California High-Speed Train Project

**RFP No.: HSR 11-16
Design Variance Report**

FRESNO STATION CROSSOVER DISTANCE FROM STATION
HST TRACK ALIGNMENT SPIRAL/VERTICAL CURVE OVERLAP
OCS CLEARANCE ASHLAN AVE
OCS CLEARANCE UNDER FUTURE RECONSTRUCTED FRESNO YARD OVERHEAD

DESIGN VARIANCE COVER SHEET

Title/Subject: HST Track Alignment Spiral/Vertical Curve Overlap

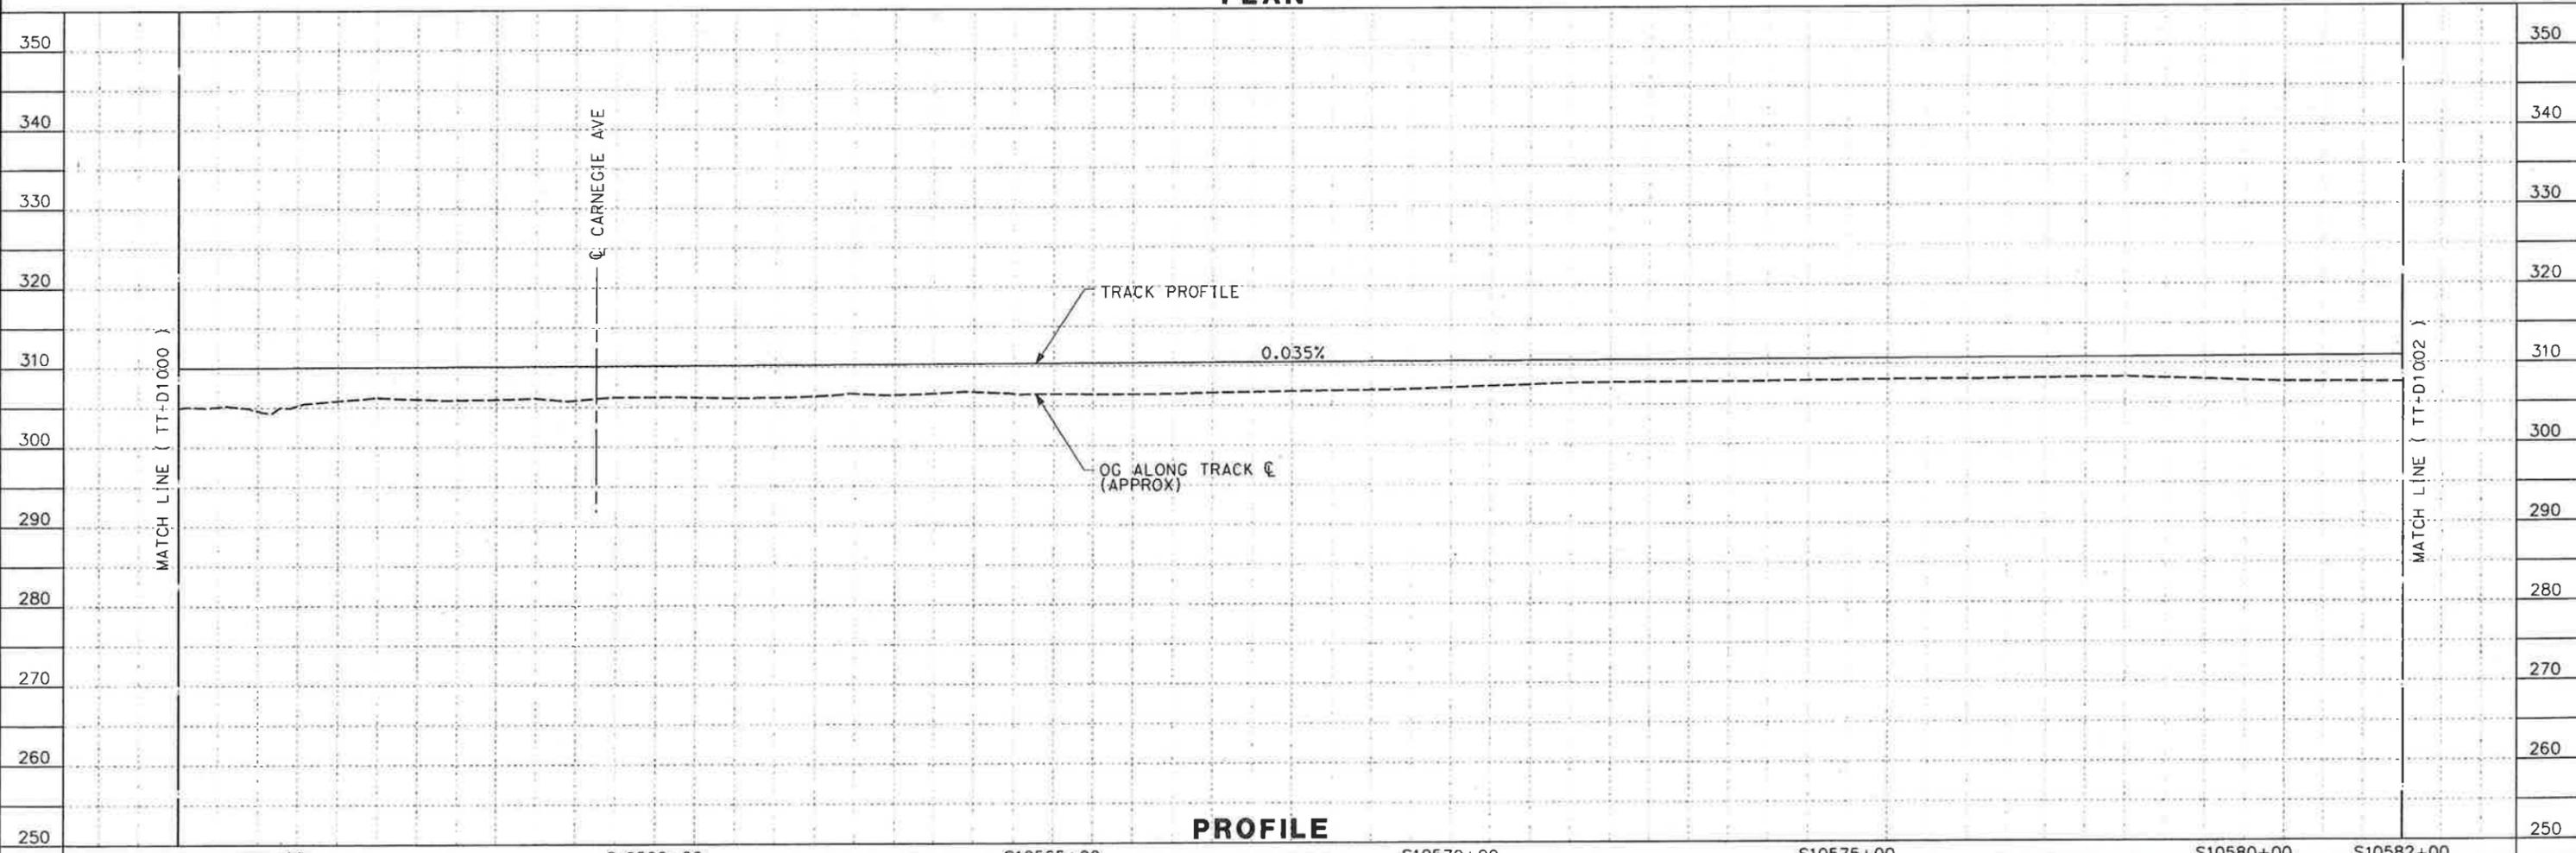
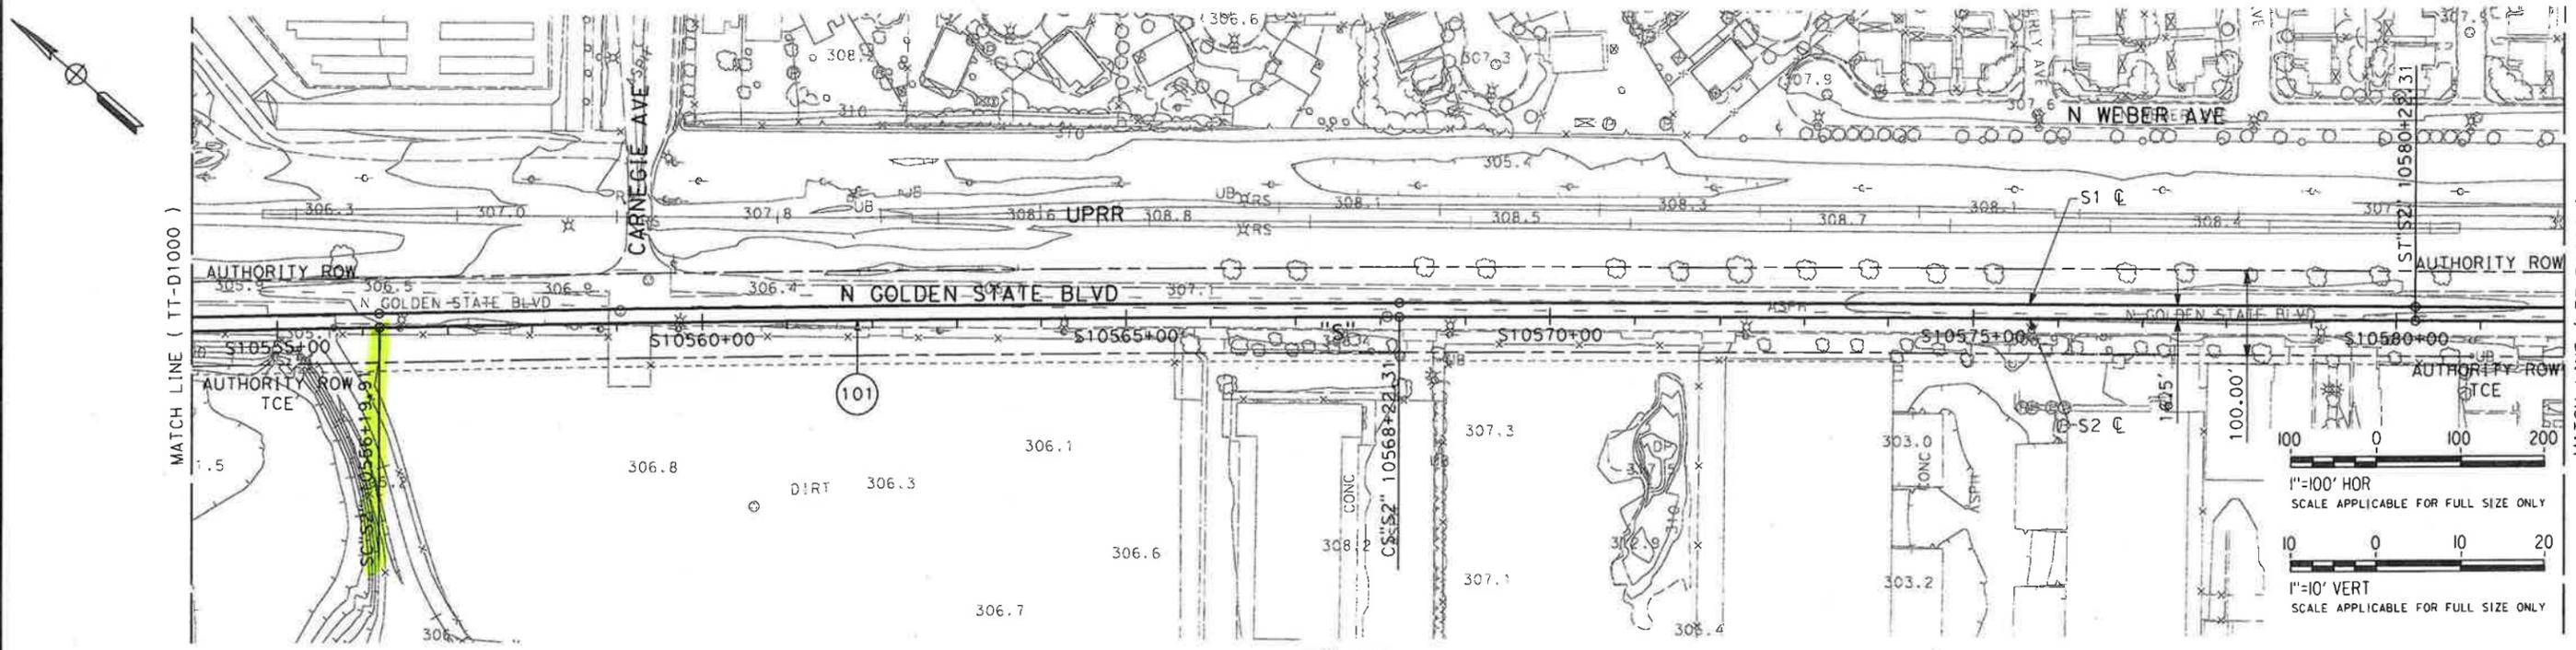
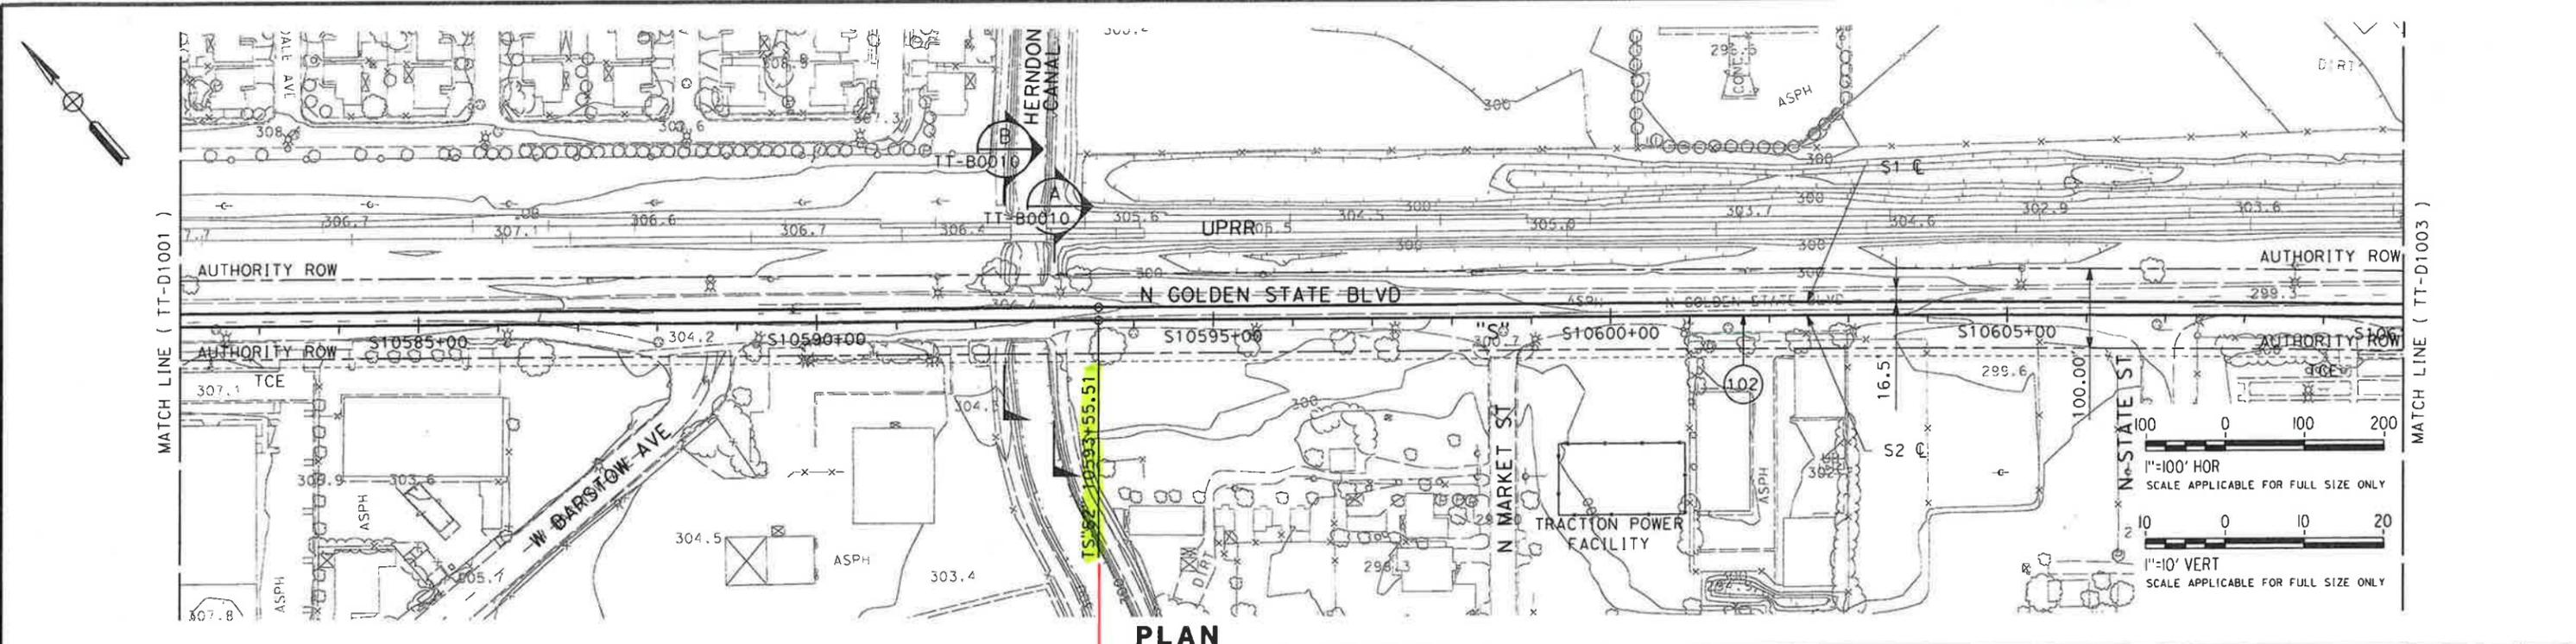
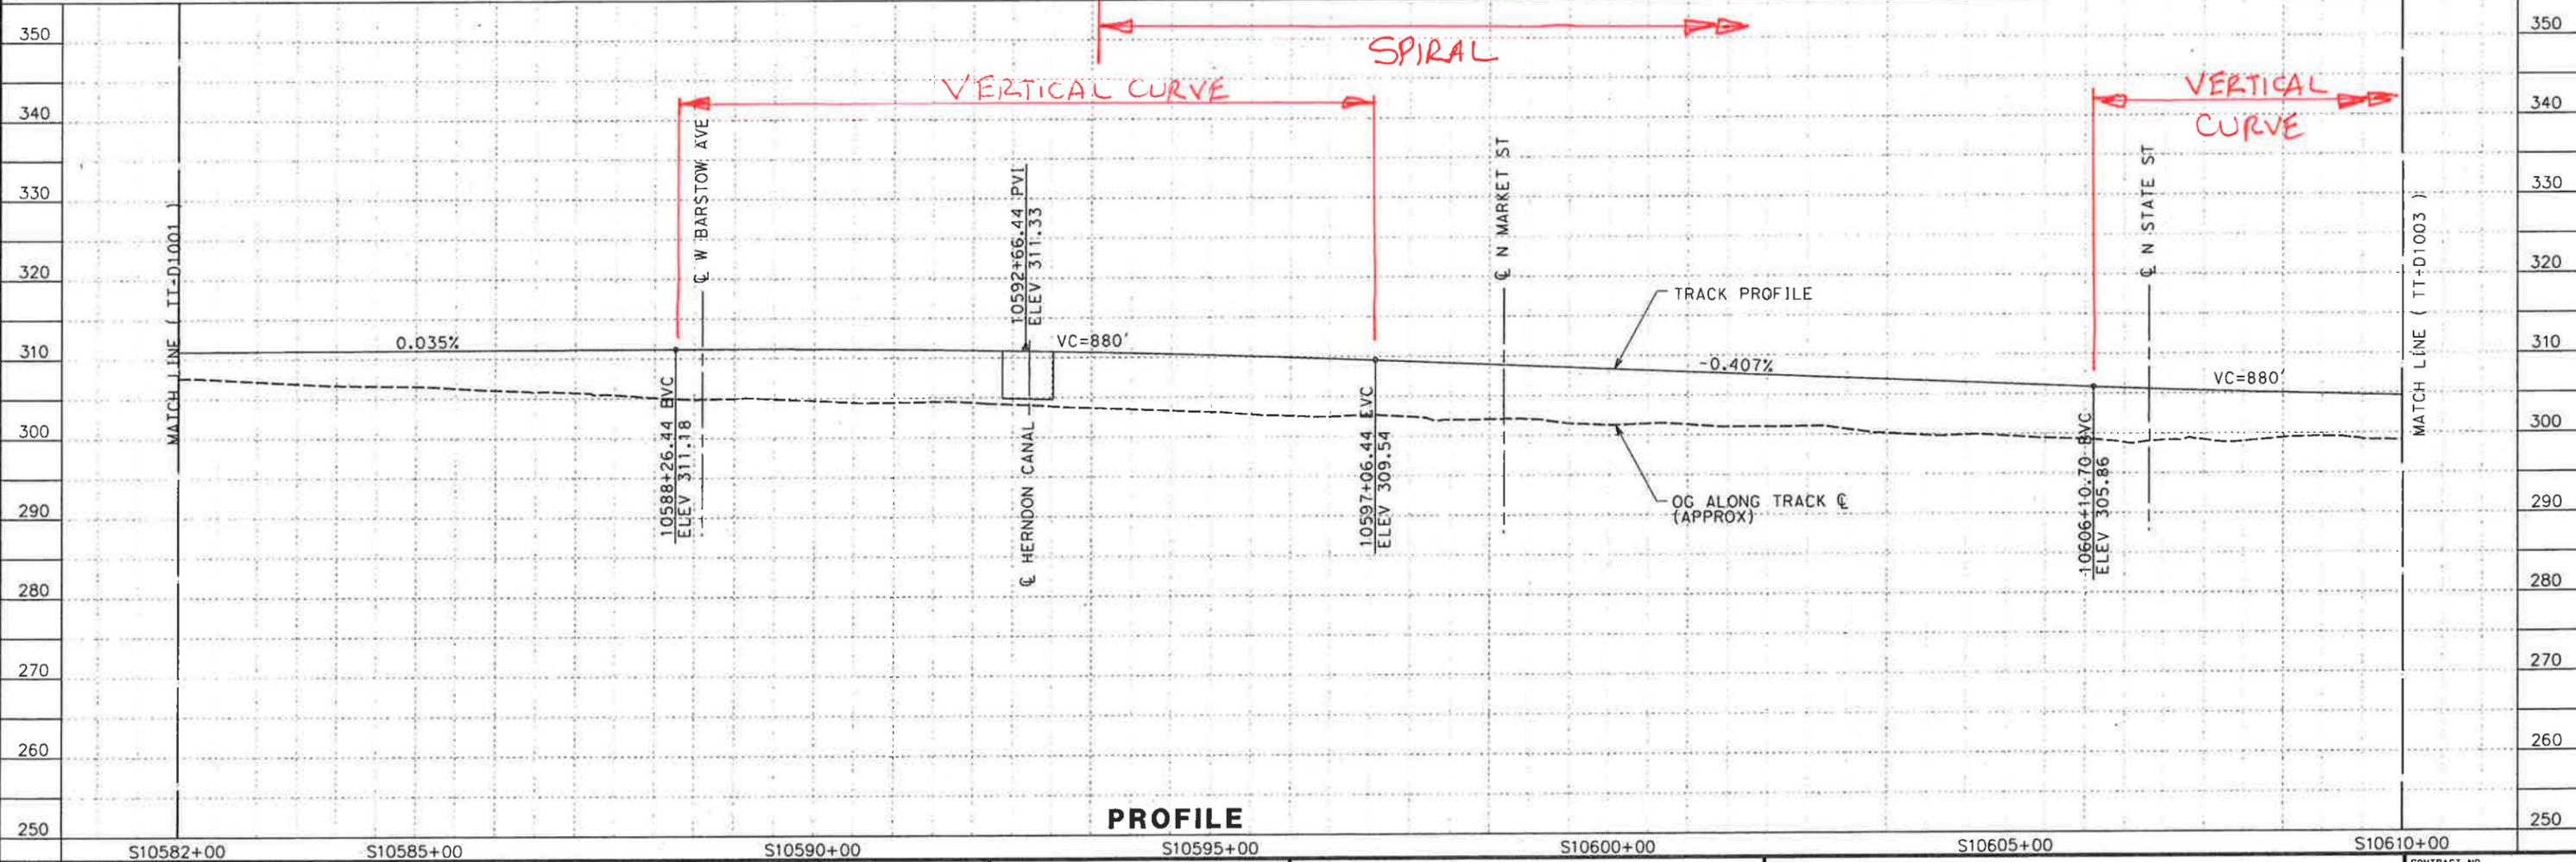
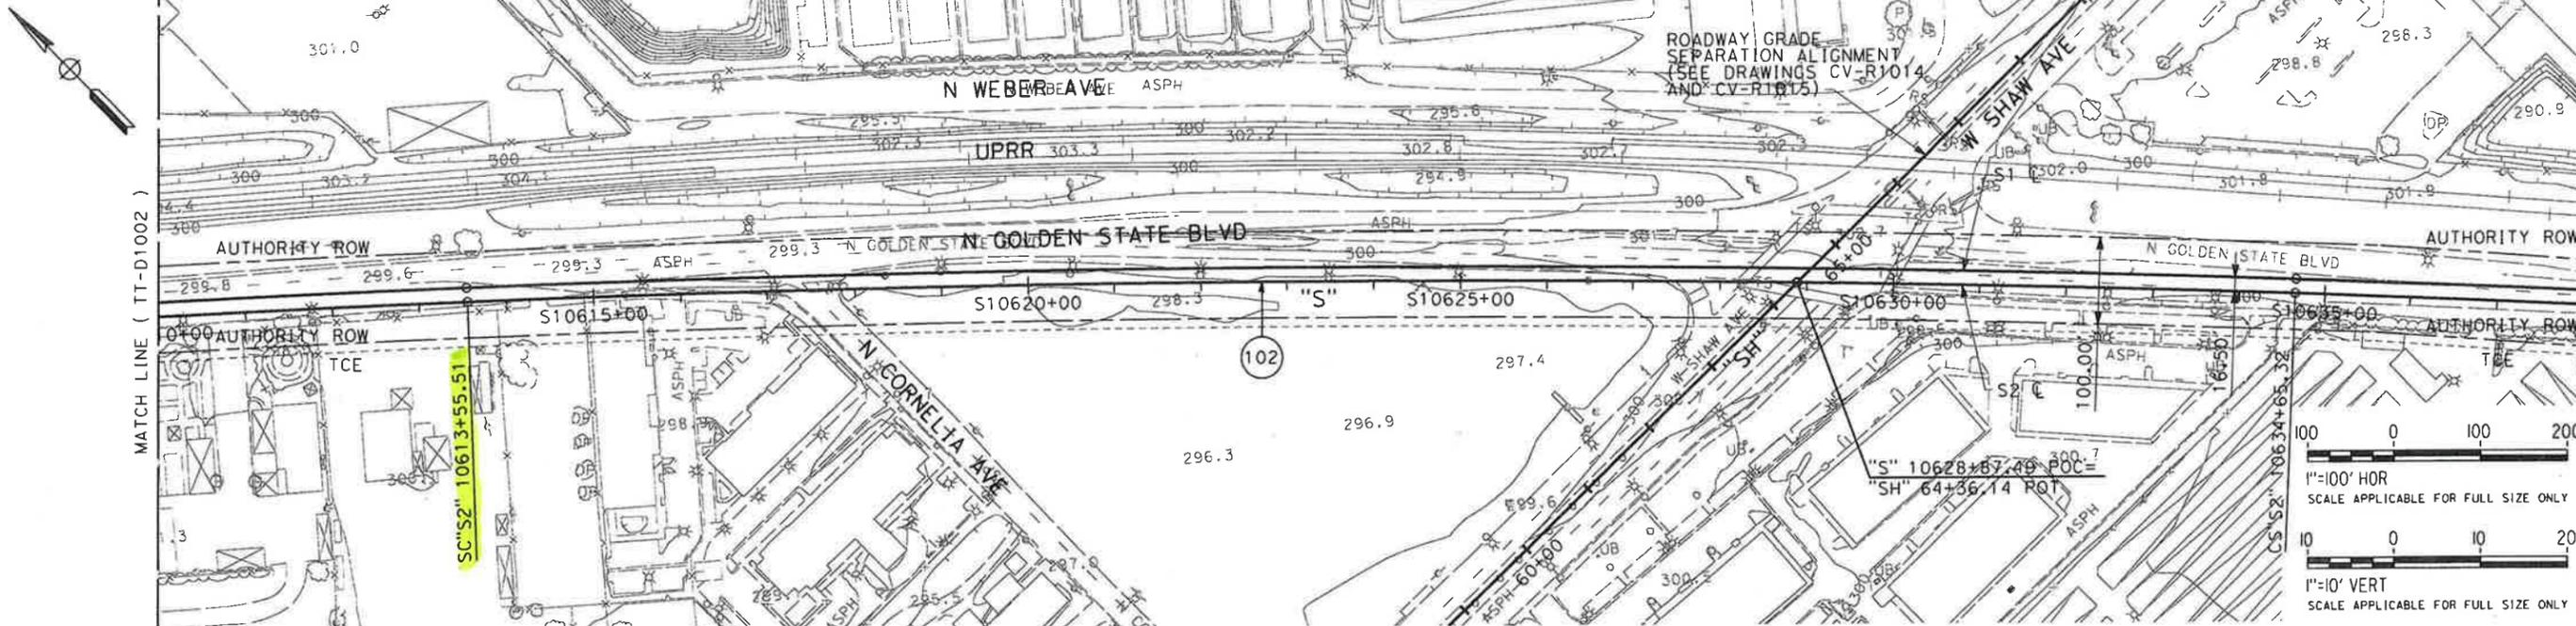
CHSTP DESIGN REQUIREMENT Include reference to drawings, design criteria, technical memos, specifications	TM 2.1.2 Section 6.1.7
DESIGN CRITERIA REQUIRING A VARIANCE	No overlap allowed between spiral curves and vertical curves for HST track alignment.
REASON FOR REQUESTING VARIANCE	To keep the top of rail profile as close to existing ground as possible thus avoiding the need for embankment fill or retaining walls.
JUSTIFICATION FOR VARIANCE	To avoid unneeded additional capital cost to the project.
PROPOSED ALTERNATIVE DESIGN REQUIREMENT	Allow overlap of vertical curves with spiral curves.

OPERATIONS	N/A
MAINTENANCE	Possible slight increase in maintenance costs due to complexity of HST track alignment.
INFRASTRUCTURE	<p>General The HST alignment must pass underneath a proposed roadway overcrossing at Veterans Blvd. (station S10535+81) and a new roadway overcrossing at Shaw Ave. (station S10628+87). Between these locations the HST alignment will cross Herndon Canal on a new bridge at station 10592+66.</p> <p>The top of rail profile is designed to pass under the two roadway overcrossings and must rise to provide sufficient structure depth for the Herndon Canal bridge while maintaining proper freeboard over the water surface.</p> <p>There are three locations where the spiral/vertical curve overlaps. Location 1 is the vertical curve at station S10548+36 which overlaps the spiral on curve #101. Location 2 is the vertical curve at station S10592+66 which overlaps the spiral on curve #102. Location 3 is the vertical curve at station S10610+51 which overlaps the spiral on curve #102.</p> <p>Reason Moving the two vertical curves identified above will result in a raised the top of rail profile between the proposed vertical curve PVI locations, a distance of approximately 4,430 feet. The top of rail would be approximately 8 feet higher along this section.</p> <p>This raised profile will require additional embankment fill along the 4,430 feet to accommodate the raised track profile.</p> <p>Other Options Another option would be to introduce additional</p>

vertical curves within this area of the alignment however this will result in a "roller coaster" type of effect for HST patrons. Justification The raised top of rail profile will require additional embankment fill, thus adding cost to the project. The increased embankment would eliminate the opportunity for open drainage ditches thus requiring a closed drainage system.
RAILROAD SYSTEMS	N/A
RELIABILITY / FUNCTIONALITY	N/A
THIRD PARTY (Utility, Freight, Caltrans, RR, other)	N/A
SAFETY AND SECURITY	N/A
DIRECT COST	No detailed cost estimate. The increased cost of the embankment and inclusion of a closed drainage system would alone will be in excess of \$500,000.
OTHER	Possible increased maintenance cost of drainage system.
